CITY OF ALBUQUERQUE

RE: **1105 Juan Tabo Blvd NE**
Grading Plan Stamp Date: 4/28/20
Hydrology File: J21D024

Based on the submittal received on 5/4/20 the above-referenced Grading Plan and Drainage Report is approved for Building Permit.

C-100

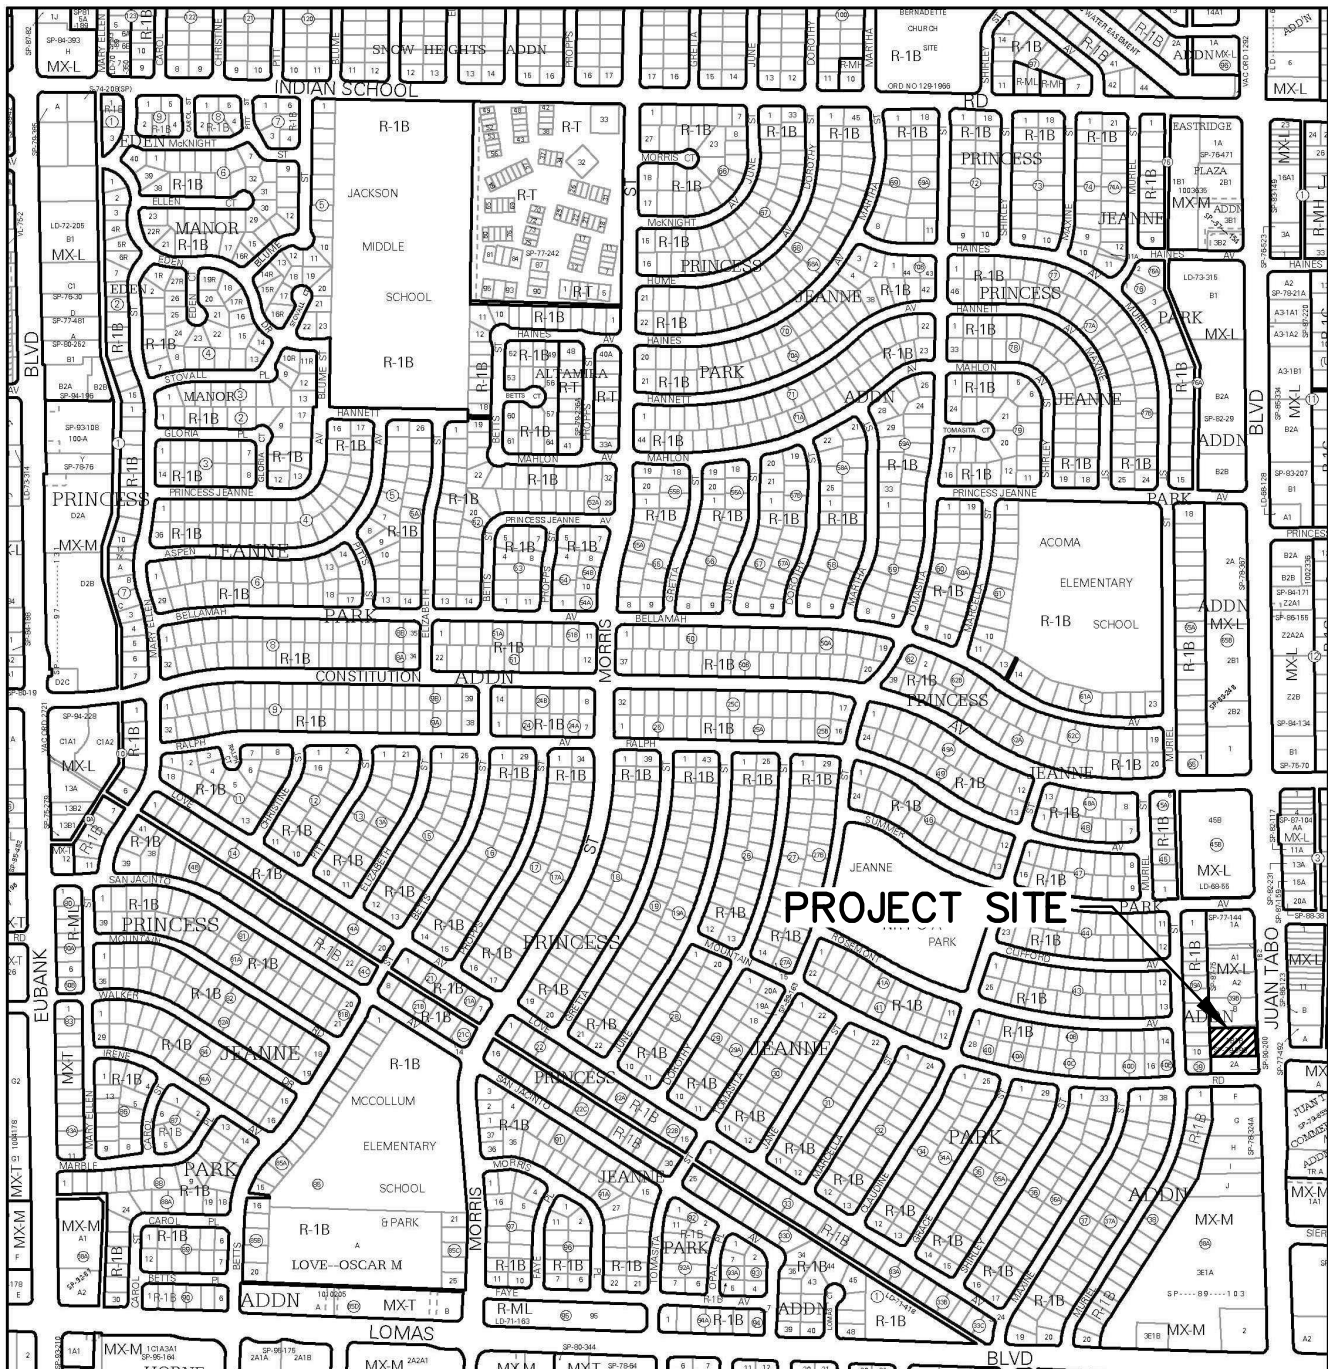
1. Payment in Lieu (Amount = 358 CF x \$8/CF = \$2864, per sheet C-100 for Basin B) of onsite management of the SWQV must be made. Take three copies of the treasury deposit slip to the Treasury and then include one copy of the paid deposit slip when resubmitting.
